stm32-blinky — Design Document

Board review: stm32-blinky (P8 adversarial pass)

reports/renderers/stm32-blinky_top.png

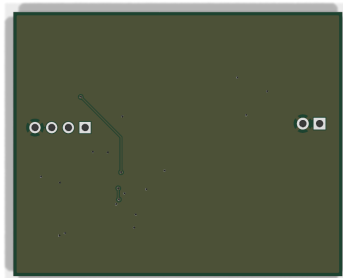
ERROR 1 - J1 power input has no polarity legend on silk (requirements miss)

requirements.md sec 2 and architecture/blocks.md both promise the 5 V input "polarity marked on silkscreen" (J1 pin 1 = +5 V, pin 2 = GND). The as-built board has NO text or +/- legend anywhere: silk carries refdes only (there is not a single gr_text on the board). What exists at J1 is a pin-1 dot and a square pad (see crop-j1_d1.png) - and the dot sits on the header body outline,

so after the header is soldered the plastic covers it. Post assembly the top side shows nothing but "J1"; the square pad is visible only from the bottom.

Consequence: the unkeyed 2-pin input can be plugged backwards with no on-board hint. D1 (series SS34) prevents damage - reversed input just does not conduct - but the user gets a dead board and no way to know why or which way is right without opening the design files. This is the board's primary human interface and an explicit requirements promise. Fix is two silk texts ("5V", "GND" or "+", "-") next to the holes, outside the header body. Must fix before fab; there is ample empty silk area (left region is empty).

WARNING 1 - J2 SWD pins unlabeled (architecture promise miss)

`blocks.md` promises "Canonical pin order (silk-labeled): 1 = SWDIO, 2 = SWCLK, 3 = 3V3, 4 = GND". Electrical order verified correct from the netlist (pads: SWDIO/SWCLK/+3V3/GND, U1 PA13/PA14 to pins 1/2). But there are no labels - only a pin-1 square cell (`crop_d2_j2.png`) which the header body covers after assembly. ST-Link clones are wired pin-by-pin; swapping 3V3/GND shorts the debugger's 3.3 V rail to ground. Same trivial fix as ERROR 1 (four small silk texts below the header row - the area under J2 is clear). Strongly recommend fixing together with ERROR 1; warning rather than error only because requirements.md itself demands the ORDER (met), the labels are an architecture-level promise.

WARNING 2 - refdes association ambiguity (cap cluster + C3-under-J2)

Confirmed the P6-flagged issue on `crop_u1_cluster.png` and `crop_d2_j2.png`; judged as follows:

- "C11" text sits directly above R1's body; "C1" text below-left of R1; "C7"/"C8" labels float between parts they do not touch. Among these 0603s are four DIFFERENT cap values (22 pF, 10 nF, 100 nF, 1 uF) plus a 1 k resistor - a hand-rework or debug probe guided by silk has a real chance of landing on the wrong part.
- "C3" text renders directly under J2 pads 3-4 and reads like a header label (its own body is 3.6 mm away). Mildly reinforces the J2 labeling problem: someone may read "C3" while counting SWD pins.
